*Proceedings of the Madras Government, Revenue Department,
2nd August 1872.*

No. 17. From the Acting Collector of Ganjam, to the Chief Secretary to Government, Revenue Department, Fort St. George, dated Chetterpore, 8th May 1872, No. 677.

REFERRING to paragraph 5 of the Government Order in the Revenue Department, dated 22nd February 1872, No. 326, I have the honour to forward, for the approval of Government, a plan and an estimate, amounting to Rs. 400, for protecting the tablets on the Jogada Naugam Rock, and request an allotment for the prosecution of the work which should be taken in hand at the earliest possible date.

Protective Work for Tablets Asoko's Edict

Estimate for Work
for protecting the
Tablets in the Pagan
Program Rock in
Kanyam District

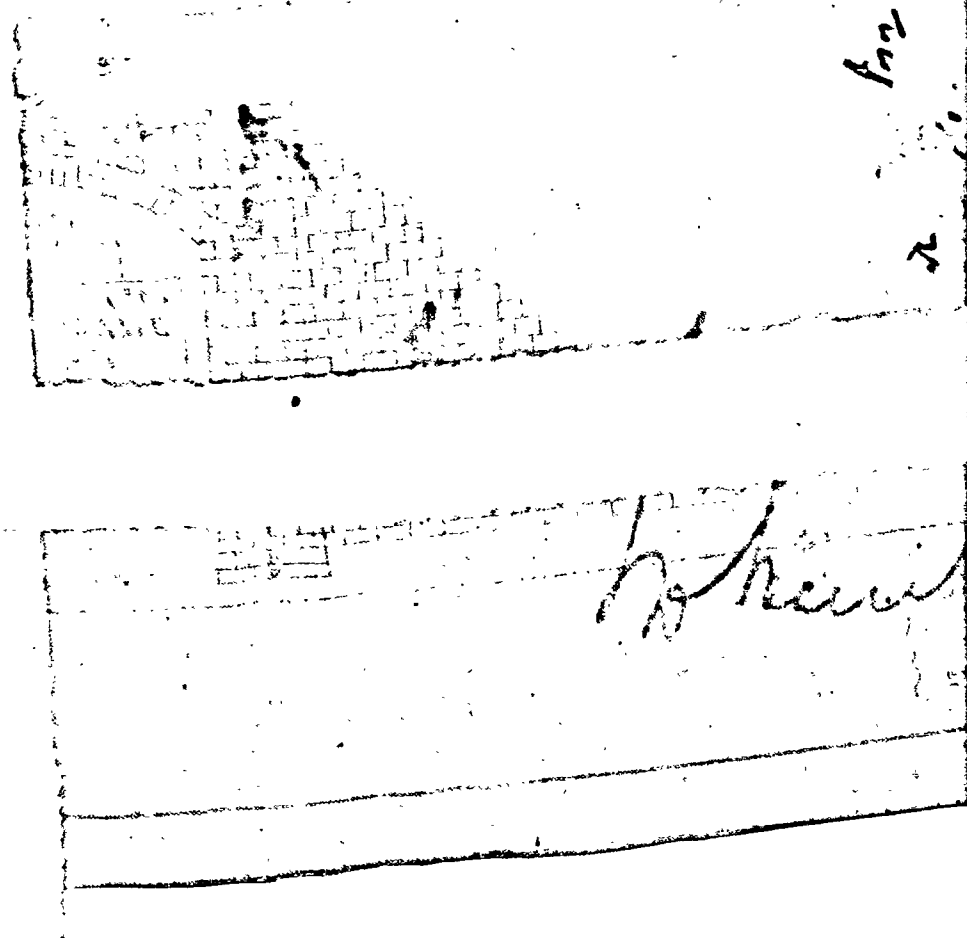
The only appropriate protection for such Tablets as these, cut in the face of natural rock, is by a flat pent roof supported in brackets, projecting a yard or a yard & a half from the face of the rock, according as it placed lower or higher above the inscription. The material to be preferred is stone - but timber may

Mr. Baldie, could
don't help design
something from
the pencil sketch
here with result -
It should not be
too highly finished
ed, so as not to
be out of keeping
with the natural
rock. - The stone
slabs about 8 feet
long, and 1 to 1 1/2 ft
wide, overlapping
each other, and
supported by three
brackets let into the
rock would be best.

—Plan & Details—

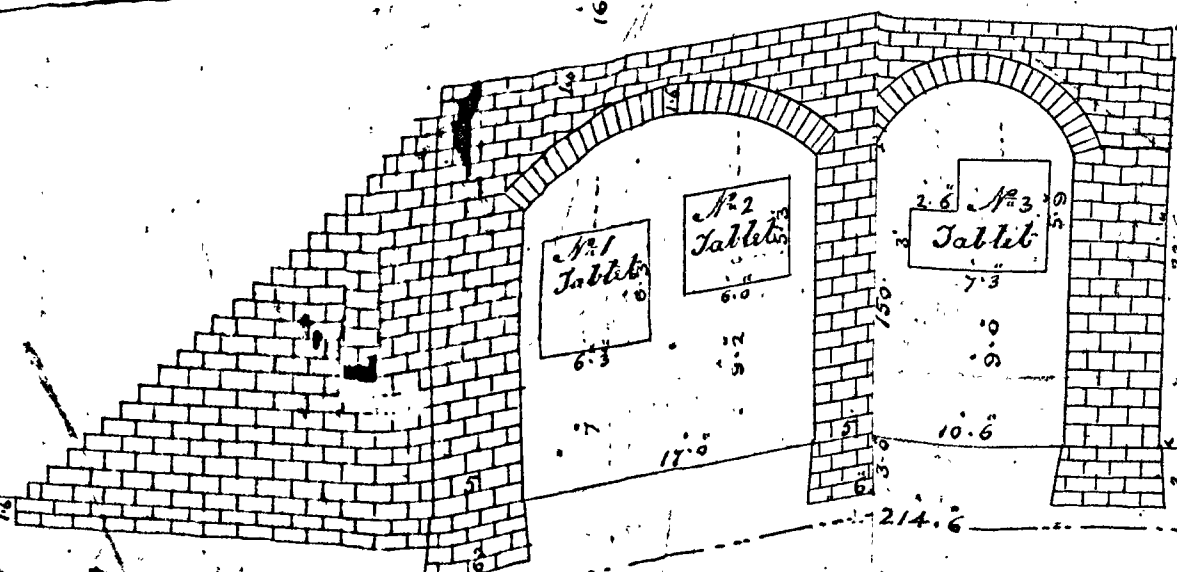
REFERRED to the Department Public Works in view to some more appropriate design for the protective work being prepared.

As it would appear from Captain Beckley's statement that the insertion in the rock of the supports for any protecting roof would very probably increase the damage that the inscriptions have already suffered by causing particles of the stone to flake off, the Governor in Council thinks it best to abandon the design of sheltering the tablets, the necessity for which cannot be very pressing.

The only appropriate protection for such Tablets as these, cut in the face of natural rock, is by a flat pent roof supported in brackets, projecting a yard or a yard & a half from the face of the rock, according as it placed lower or higher above the inscription. The material to be preferred is stone - but timber may
